Rezoning Transportation Analysis

Petition Number: #2022-089

Date	Description
11-28-22	First Review (TM)

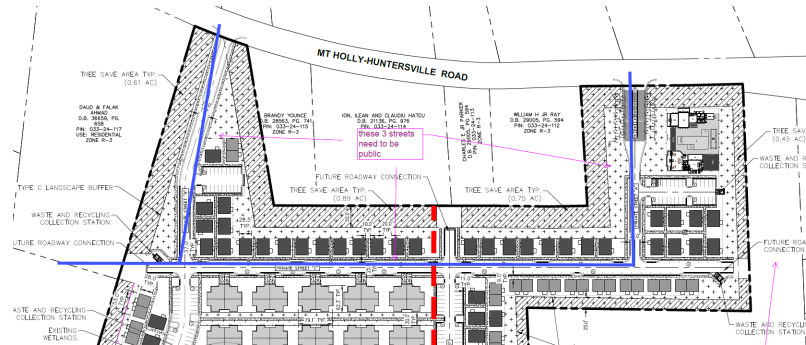
1. **Curblines:** The proposed zoning district has a setback measured from back of the existing or proposed future curblines.
 - a. **Old Statesville Road:** The future location of curb and gutter is measured at 30-feet from the centerline of the roadway to the BOC.

Label and dimension the curb and gutter from the centerline for each road on the site plan.
